IEEE 1451.4 Standard Working Group
Telephone Meeting, Nov. 9, 2000
Meeting Minutes, issued 11-09-00, Approved 08-23-01

1) T-Block: C. Lopez-Reyna

Figure 7: 1451_Dot4Transducer behavioral diagram

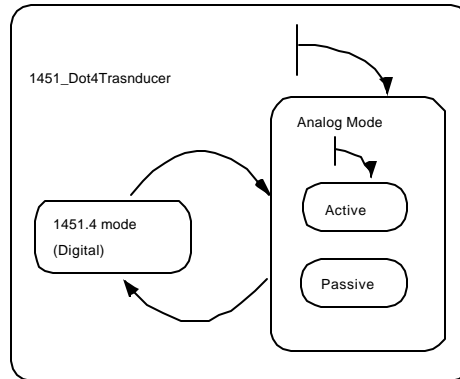
Active sub state: Internal electronics of the 1451_Dot4Transducer allow analog sensor voltages to flow into the transducer interface. {If this is the default start up state then there is a potential conflict with multi drop configuration if the transducer interface starts in legacy analog mode. Solution is to set the 1451_dot4Transducer interface always in digital mode when in Multi-drop configuration }

- b) The T-Block always leaves the Transducer Interface in the analog mode. There are no indeterminate states.
- c) Request for examples of node lists from any members who have used them.
- d) Typo in sec M.M.2.1.2, Analog Mode, Active Sub-state, Reference to flow of voltage. Should refer to flow of current. CLR to revise.
- e) A section has been added to allow digital-only nodes.
